City of Portland, Oregon
Bureau of Development Services
Land Use Services

SUMMARY MEMORANDUM

RE: EA 18-138980 DA, Adidas Village Expansion
April 26, 2018 Design Commission Hearing; DAR 1 Site & Massing
May 24, 2018 Design Commission Hearing; DAR 2 Architecture & Landscaping

2) Entry Pavilion

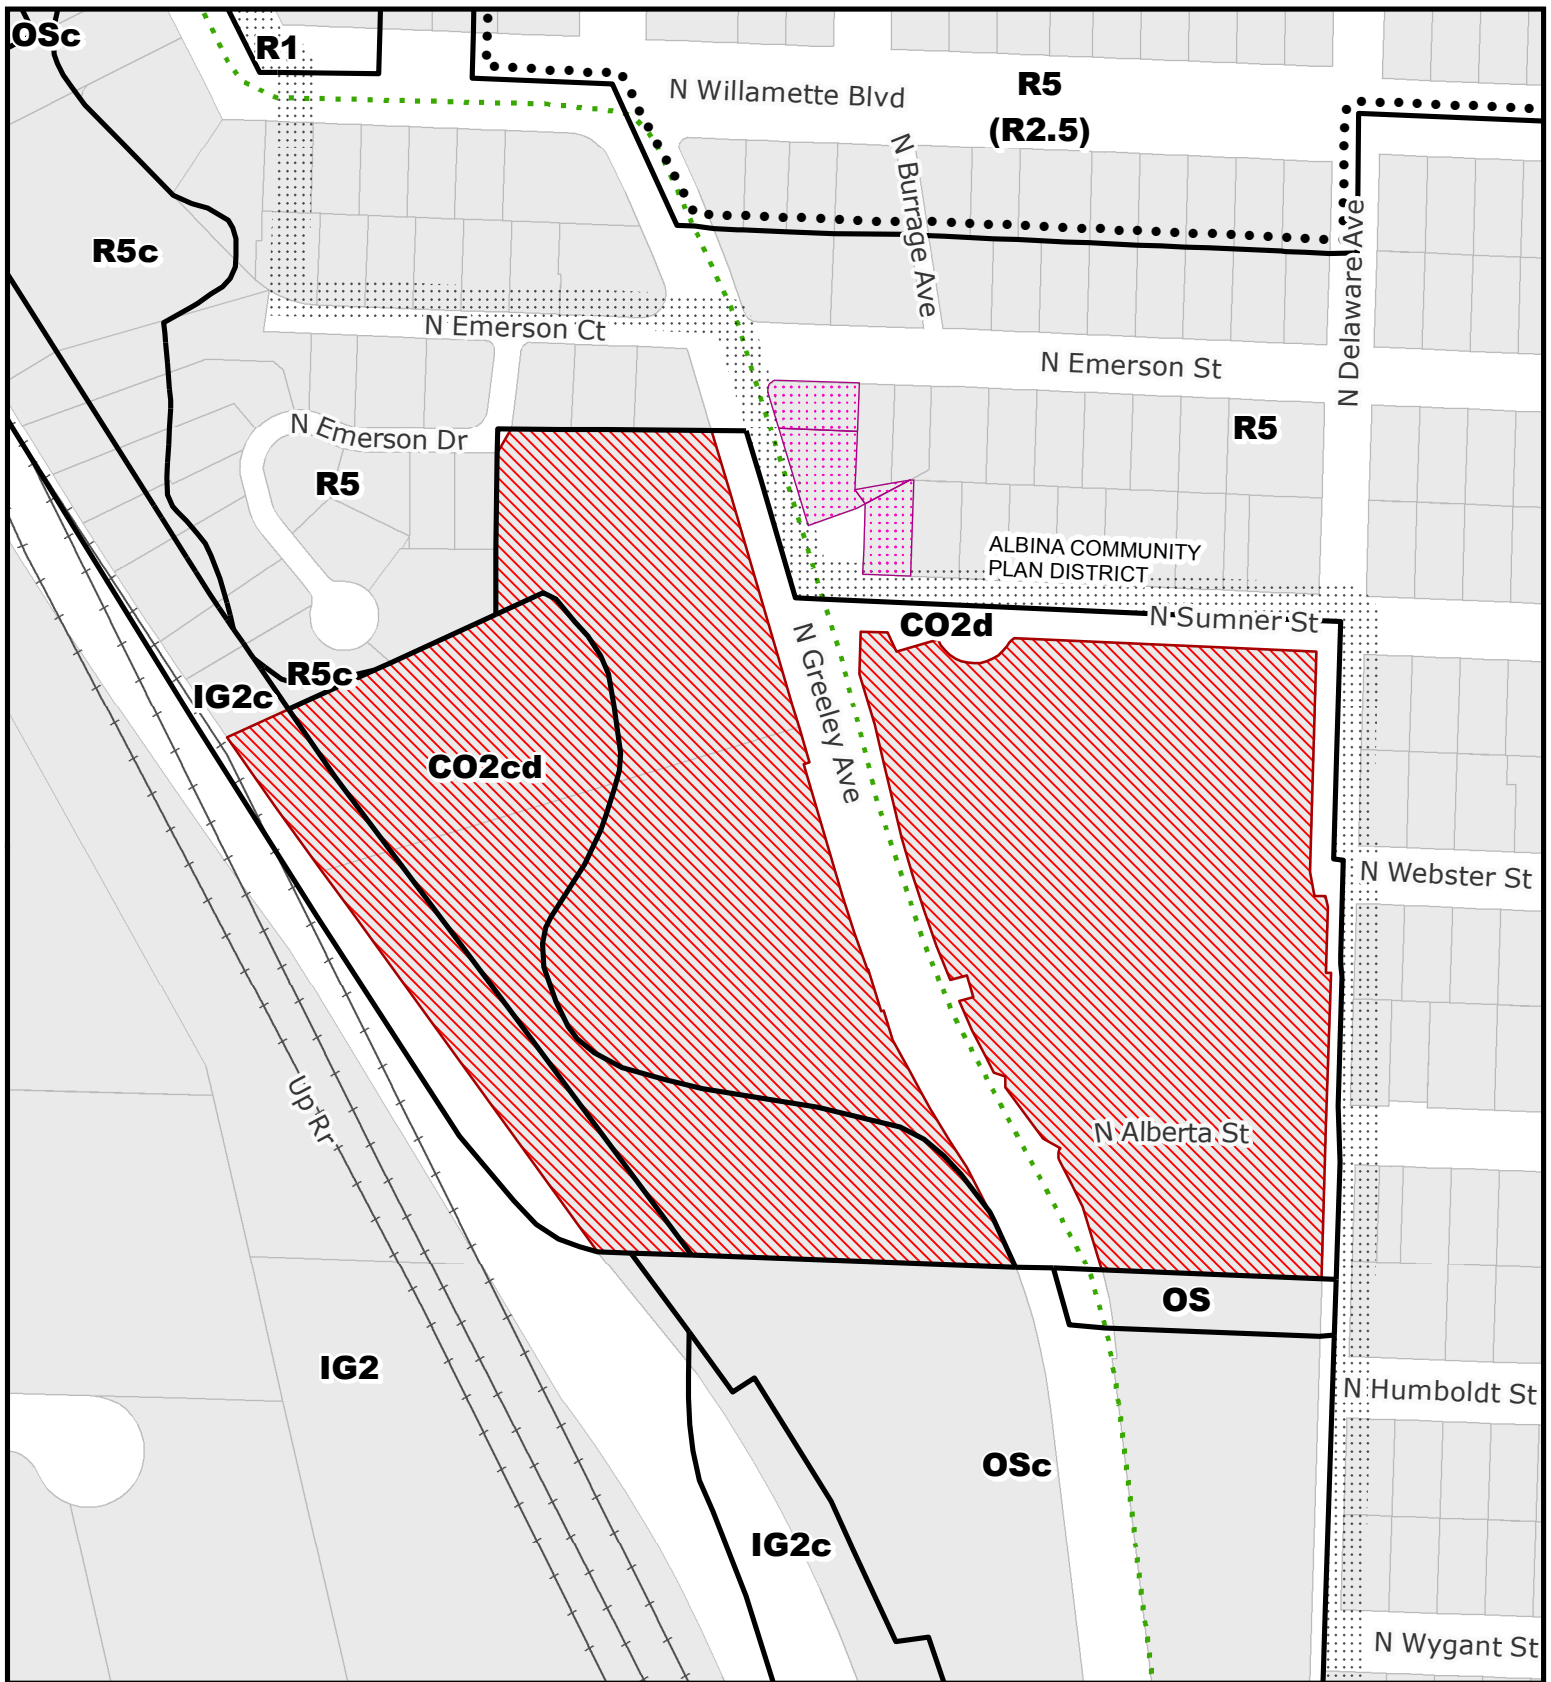
- As the pavilion is intended to evoke both artwork and icon, express the values of Adidas – not just a shoe – but the creativity, sustainability, ingenuity, for example. Expressed in abstract would be appropriate.
- Commissioners agreed that whatever the design, must be integrated with the overall Village Park design.
